Palo Verde Nuclear
Generating Station

**Subject: Palo Verde Nuclear Generating Station (PVNGS)
Units 1, 2 and 3
Docket Nos. STN 50-528, 50-529, and 50-530
Response to NRC Request for Additional Information Regarding
PVNGS Units 2 and 3 Steam Generator Tube Inspections**

**ARIZONA PUBLIC SERVICE COMPANY
RESPONSE TO NRC REQUEST FOR ADDITIONAL INFORMATION
REGARDING PVNGS UNITS 2 AND 3 STEAM GENERATOR TUBE
INSPECTIONS**

Figure 1
MRPC Graphic "Abnormal" Dent

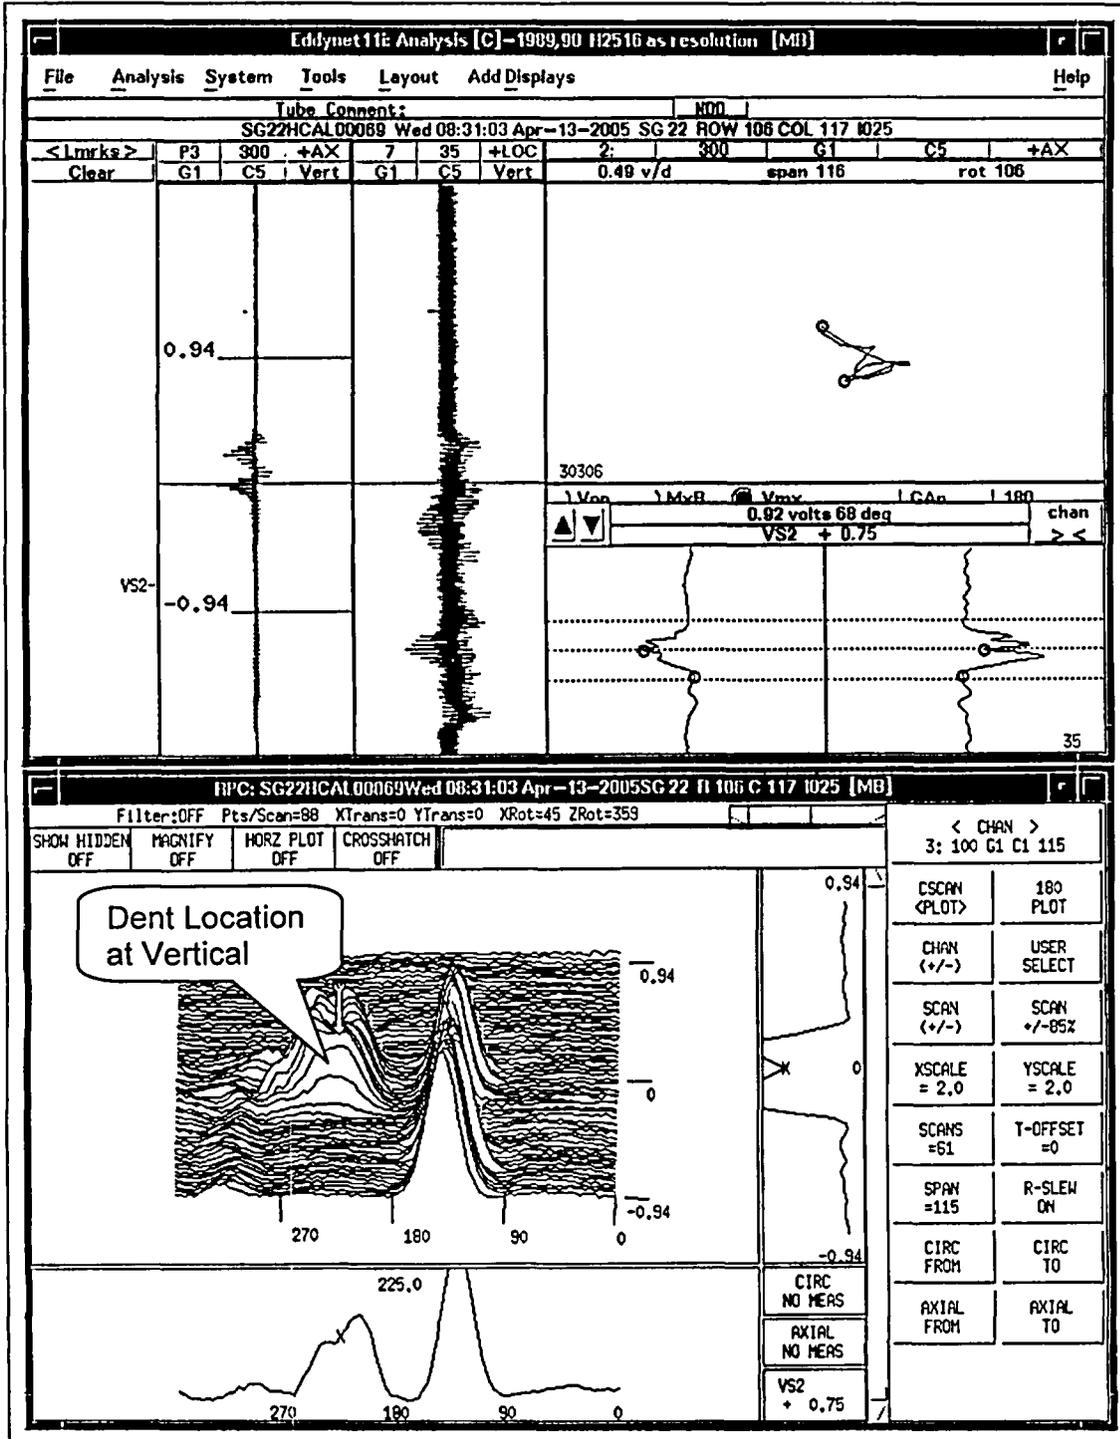
In Section 4.0 of your October 24, 2005 letter, you indicated that for steam generators 21 and 22, tubes were detected with abnormal dent indications. Were these indications present since the pre-service inspection? If so, please discuss whether they have changed since the pre-service inspection and the reasons for any change. If they were not present in the pre-service inspection, please discuss the cause of the dents. Please discuss whether these dents are considered "abnormal" since they are similar to the dent indication that was the cause of your 2004 primary-to-secondary leak.

All of the dent indications listed in Section 4.0 of the October 24, 2005 letter were present during the pre-service examinations (PSE). No changes were noted in any of the dent rotating coil examinations. The source of these abnormal dents was most likely the product of the initial steam generator assembly. All four abnormal dent indications (three in SG 21 and one in SG 22) appear to be directly associated with a vertical strap support bar. Note the NDE graphic in attached Figure 1 which indicates that the location of the rotating coil dent indication is at the vertical strap (VS2).

These dents were considered "abnormal" by APS because they exhibited vertical amplitudes higher than typical dent indications. This condition/classification is one of the lessons learned during the 2004 midcycle (leaker) outage and subsequent dent evaluations. The PVNGS Analysts' Technique Sheet for the +Point examination of dents requires the analysts to record any dent with a vertical amplitude over 0.2 volts with the +Point 300 kHz channel. These are then reviewed by the APS Level III for location, appearance, and the potential for masking of other types of flaw indications.

The abnormal dent indications were similar to the dent indication in SG 21 Row 156 Column 143 that leaked during Cycle 12 in that they had higher vertical voltage than other typical dent indications. Using the +Point 300 kHz channel, the vertical amplitude of the leaking tube was 0.94 volts compared to voltages of 0.29, 0.30, 0.67 and 0.92 for the tubes listed in Section 4.0. As indicated above, the four tubes in U2R12 were associated with a support bar, whereas the dent in the leaking tube was not directly associated with a support bar and the dent in the leaking tube was attributed to damage caused by a packing crate screw.

Although it is unlikely that these dents were caused by crate screw damage, APS took the conservative action and removed the affected tubes from service by plugging.

Figure 2
Set Screw Installation Unit 1 and 2 RSG

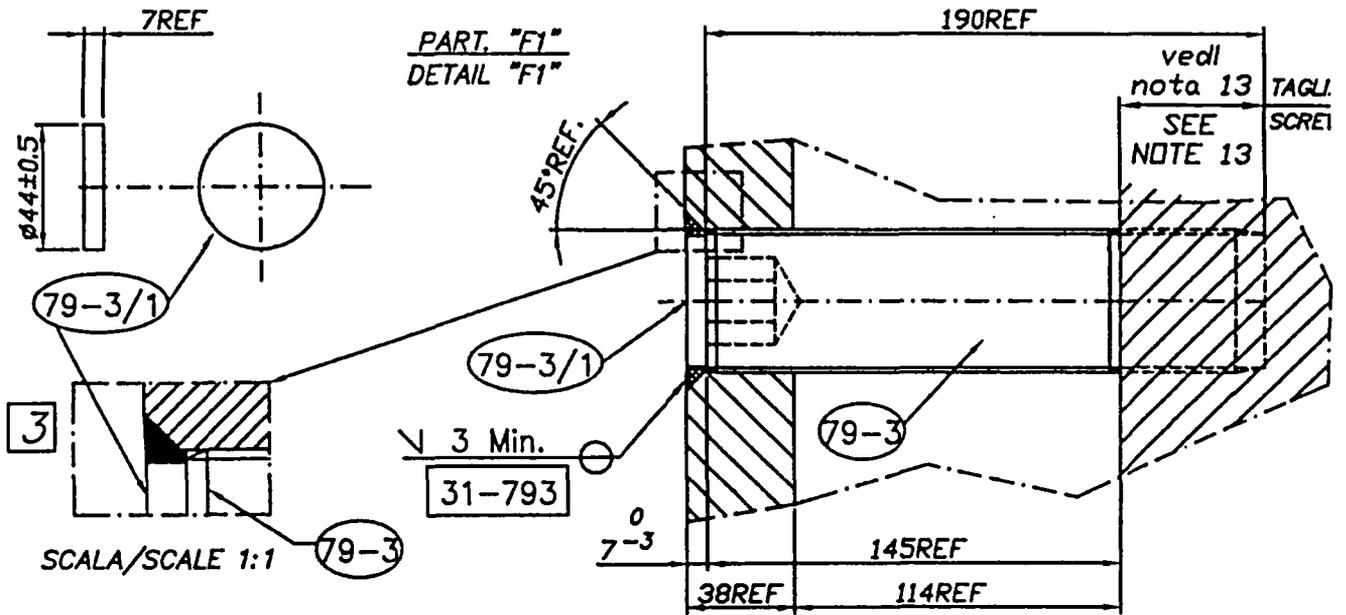
It is the NRC staff's understanding that the Palo Verde, Unit 2, replacement steam generators have an economizer with a similar set screw configuration as that in Unit 3 (which experienced degradation). As a result, please discuss whether any inspections were performed to confirm the integrity of these locations. In addition, please discuss whether any other secondary side inspections were performed during the outage.

The main design differences between the original steam generators (OSGs) and RSGs with respect to the feedwater box include; the set screw length exposed to feedwater flow, the gap setting against the shell and the set screw installation technique. The difference in set screw material (SAE Gr.5 vs. SA-193 Gr. B7) was not judged to be a significant difference.

The increased set screw length exposed to feedwater flow was evaluated with respect to the possible negative effect of increased flow forces on the set screw. The increased force on the set screw was calculated to negligibly increase by approximately 3% in the RSGs. Alternatively, the increased length permitted setting the gap between the set screw and the shell at 0.06 inches in the RSGs vs. 0.25 inches in the OSGs. This was evaluated to have a positive effect during accident

conditions. Although not likely to help limit the erosion or wear of the feedwater box at the set screw location, if erosion does occur, the combination of the smaller gap and the seal plate on tube side of the feedwater box would limit the movement of the set screw. As a result, it is less likely that the same amount of erosion as seen in the Unit 3 OSGs would lead to a set screw failure.

The most significant difference between the OSGs and the Unit 1 and 2 RSGs is the installation of a seal plate. In the OSGs the set screws were welded to the tube-side face of the feedwater box then ground flush. Because of the hardness of the set screw material, very little of the weld metal adhered to the set screw. As a result, there was a small leak path through the threads that allowed water to leak from the feedwater box to the economizer region of the steam generator. Conversely, the Units 1 and 2 RSGs have a 0.25-inch carbon steel plate that is groove-welded flush to the tube-side face of the feedwater box (see attached Figure 2). This seal plate is a significant design improvement in the RSGs. Although the primary purpose of the seal plate was to avoid welding to hardened bolting material, it has the secondary effect of eliminating the jetting flow through the set screw hole if the set screw falls out. While this change might not significantly affect the probability of a set screw failure in Units 1 and 2, it will have a significant effect on the consequences of a failure.

Based on this evaluation, APS concluded that the probability of a set screw failure is marginally lower in the Unit 1 and 2 RSGs than in the OSGs. It should be noted that the erosion/corrosion that led to the set screw failure in the Unit 3 OSG occurred after 11 operating cycles. As such, the mechanism is not considered to be a near term issue. To ensure that the condition does not manifest itself in the Units 1 and 2 RSGs, a routine Preventative Maintenance Task to inspect the RSGs in this region on a 6Y (six year) frequency has been implemented for Units 1 and 2, and the condition has been incorporated into the PVNGS Degradation Assessment.
